Access Compliance Report

Public Rights-of-Way

(Curb Ramps)

Intersection ID: 13414	Main Street: MCCLINTOCK_RD	Cross Street: ST_JULIEN_ST	Location: S
ADA ID: 3AD3FAFA9D09	Ramp Type: Perp	Initial Pass/Fail: Fail	Overall Compliance: No
		Severity Score: 22.5

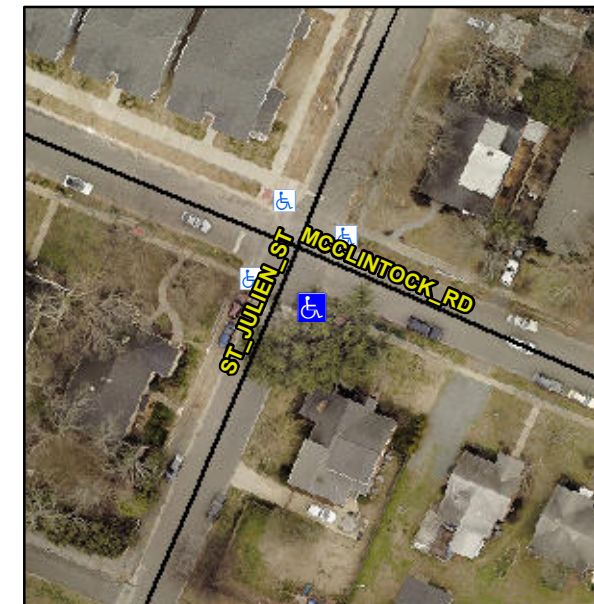
R304.5.1, R304.2.2, R304.5.3

Compliance	Description	Data	Compliance	Description	Data
N/A	Ramp Length (in)	55.0	No	Ramp Slope (%)	8.4
No	Ramp Width (in)	47.0	No	Ramp XSlope (%)	3.3
N/A	Flare Type LT	N/A	N/A	Flare Type RT	N/A
N/A	Flare Slope LT (%)	N/A	N/A	Flare Slope RT (%)	N/A
N/A	Flare Traversable LT?	N/A	N/A	Flare Traversable RT?	N/A
N/A	Landing Length (in)	N/A	N/A	DWS Provided?	N/A
N/A	Landing Width (in)	N/A	N/A	DWS Contrast?	N/A
N/A	Landing Slope (%)	N/A	N/A	DWS Length (in)	N/A
N/A	Landing X Slope (%)	N/A	N/A	DWS Full Width?	N/A
N/A	Landing Curb? (Y/N)	N/A	N/A	DWS Offset (in)	N/A
N/A	Shared Landing?	N/A			
N/A	Gutter Ponding?	N/A	N/A	Gutter Slope (%)	N/A
N/A	Gutter Lip Ht (in)	N/A	N/A	Gutter X Slope (%)	N/A
N/A	Painted X Walk1?	No	N/A	Painted X Walk2?	N/A
	X Walk 1 Direction	To NW		X Walk 2 Direction	N/A
N/A	X Walk 1 Width (in)	N/A	N/A	X Walk 2 Width (in)	N/A
	X Walk 1 Slope (%)	2.9		X Walk 2 Slope (%)	N/A
	X Walk 1 X Slope (%)	3.3		X Walk 2 X Slope (%)	N/A

Remove & Replace Entire Ramp.
